Service Bulletin

Bulletin No.: PIP6031C

Subject: CVT Transmission Leaks From Case Half

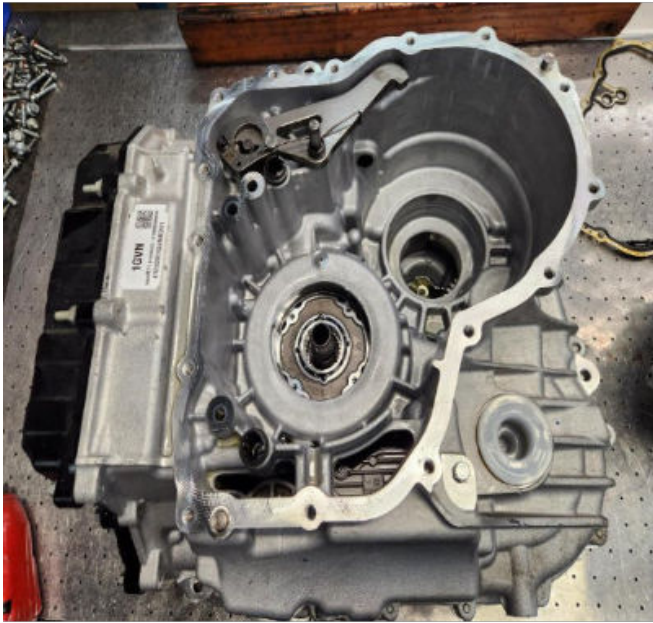
Technicians may find a leak coming from the case halves.

Separate the Case halves and inspect for Machining Imperfection.

Machining Imperfection as seen below can be repaired by block sanding the case with either 400 or 600 grit sandpaper then replacing the gasket.

Note: When sanding the case attention must be paid to prevent taking off too much material, all that needs to be done is to remove the machining damage to the case.
